- 1 **298-312 Blaxland Road, Ryde - Demolition of existing structures; new multi-dwelling housing development containing 30 dwellings (9 x 2 bed, 20 x 3 bed, 1 x 4 bed, including 3 adaptable dwellings) over a split basement containing 63 car parking spaces, under Division 1 of State Environmental Planning Policy (Affordable Rental Housing) 2009 - LDA2020/0247**

Report dated: 03 February 2021

City of Ryde Local Planning Panel Report

Figure 17: Driveway and Public Art Zone

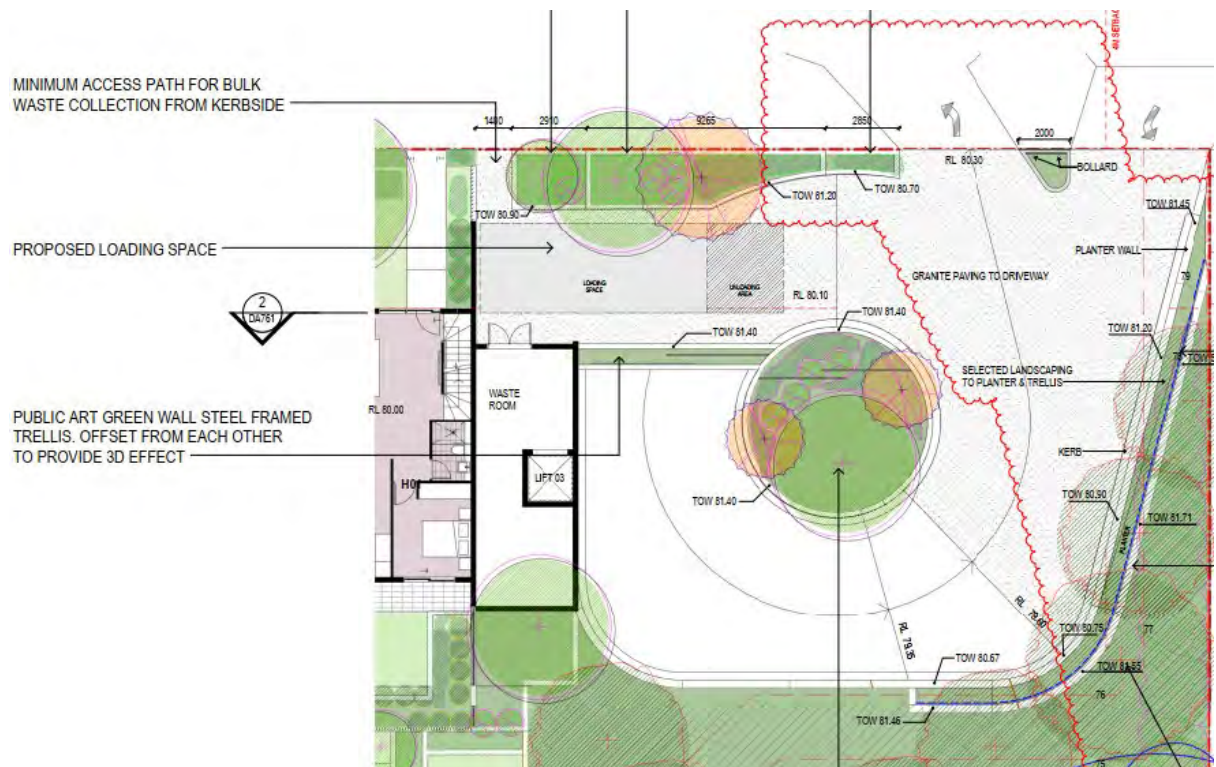
Comment: The proposal provides compliant car parking and the submitted Traffic Report concluded that the proposed development will not have any unacceptable implications in terms of road network capacity or off-street parking/loading/access requirements. The traffic report does acknowledge that Blaxland Road is affected by clearway restrictions. The site has no frontage with any other street and therefore it is not reasonable for Council to insist that access be from any street other than Blaxland Road. However, the access arrangement results in unacceptable streetscape impacts.

Figure 19: Extract from survey plan showing the rear deck located at 312 Blaxland Road

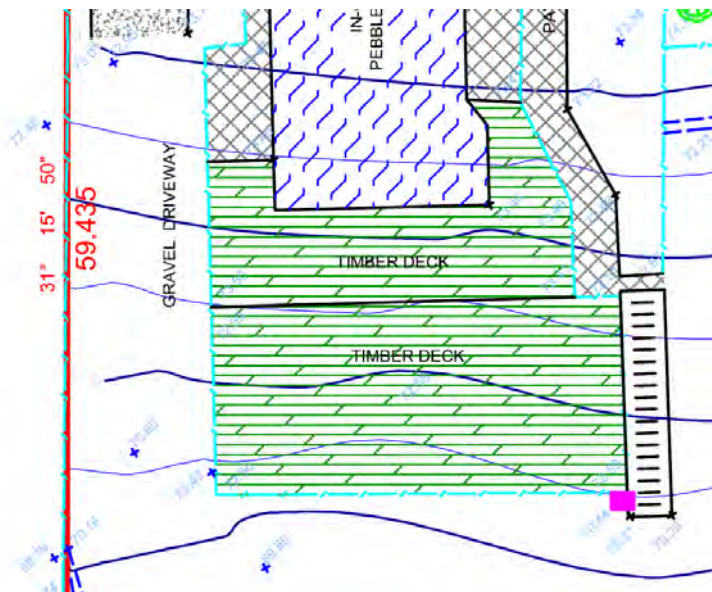
It should be noted that the extent of the variation is based on limited information on levels contained within the application, particularly with respect to the submitted section plans. In relation to Dwellings H13, H14, and H15, the submitted survey depicts contours beneath a deck located on site as shown below.

The submitted section plan appears to have partially utilised levels associated with the timber deck to depict the existing ground level in the location of Dwellings H13 – H15, as shown below.

This may be the reason that H13 was not nominated as non-compliant within the application documentation. However, the west elevation depicts ground levels noted as showing the "extent of existing ground line at House 12 façade" (bold dashed line), which can be used to estimate the height non-compliances.

Figure 21: Extract of West Elevation showing the roof levels of Dwellings H13 – H15.

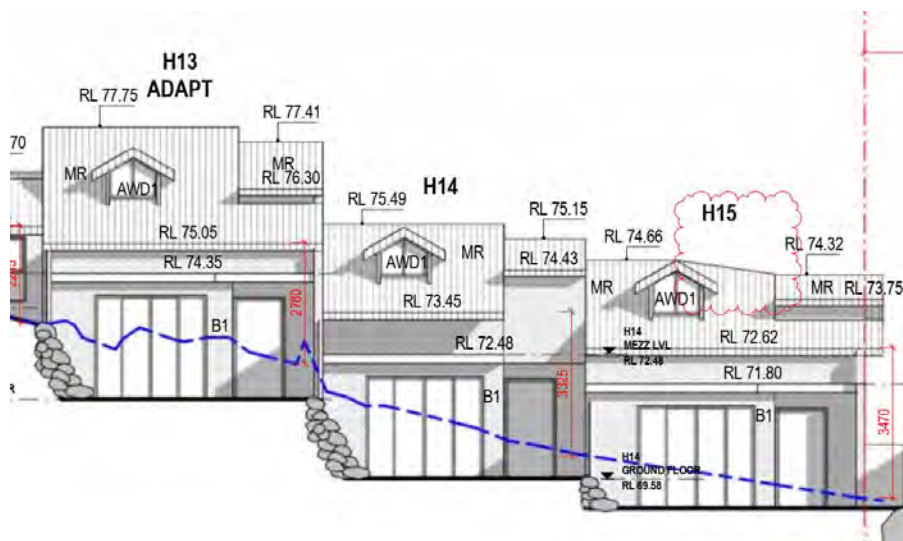
A comparison made between the site plan and the survey indicates that the lowest ground level (existing) in the location of Dwelling H13 appears to be approximately

RL 71.50; however, further confirmation was sought from the applicant. The lowest roof height of this dwelling is shown on the elevation plan to be RL 77.41 as depicted in the image above. The maximum height of this dwelling is therefore potentially up to approximately 5.9m.

Figure 22: Extract from the Elevations Plan showing examples of proposed cut to Dwellings H19 and H20 (natural ground line is shown dashed)

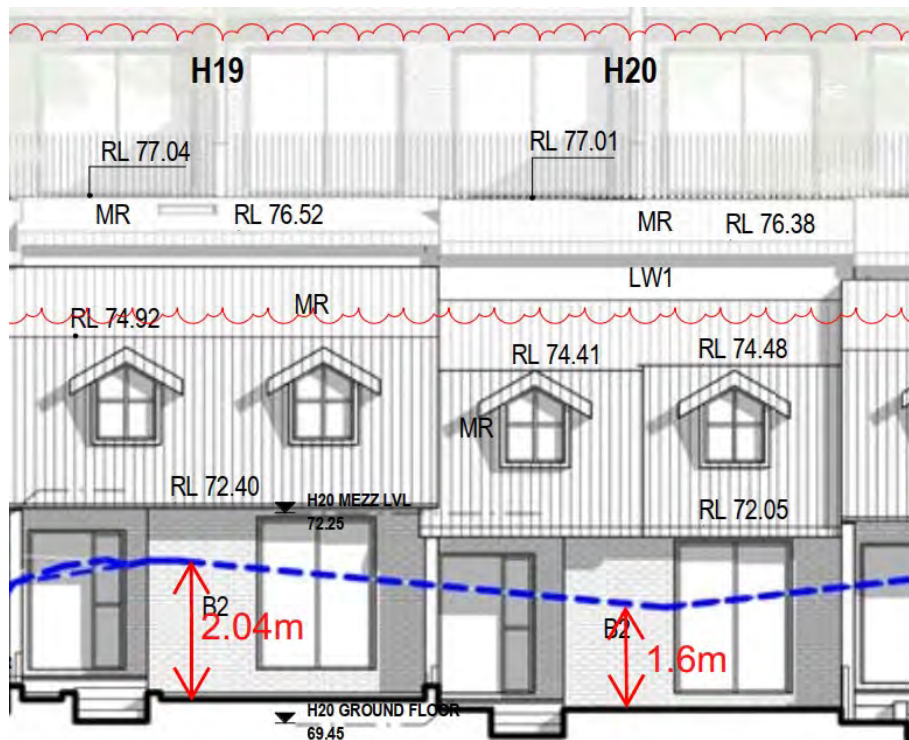
Inadequate section plans are provided to gain a thorough understanding of the level of cut and fill proposed across the site. However, the plans depict in excess of 2m of both cut and fill to accommodate individual dwellings; examples are shown below.

A similar level of earthworks is likely to be found throughout the development.

Figure 28: Examples of non-compliant ceiling heights within the development. It is noted that ceiling heights do increase beyond the measurements shown, but remain non-compliant under a low-pitched roof

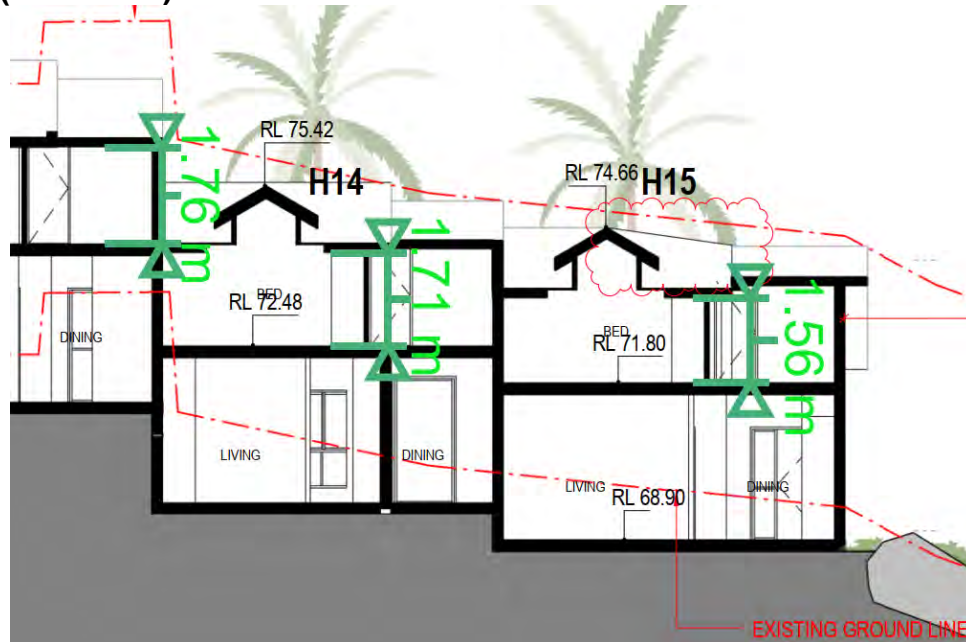
Section 4.2(a) prescribes that floor to ceiling heights must not be less than 2.7m. The submitted section plans indicate that a significant number of dwellings within the development include components that have floor to ceiling heights less than 2.7m, with some dwellings containing floor to ceiling heights as low as 1.56m within Unit H15.

The level of light, space and ventilation within the development would be compromised as a consequence of the low ceiling heights. The floor to ceiling heights highlight the difficulty in accommodating the dwellings within the permitted building heights.
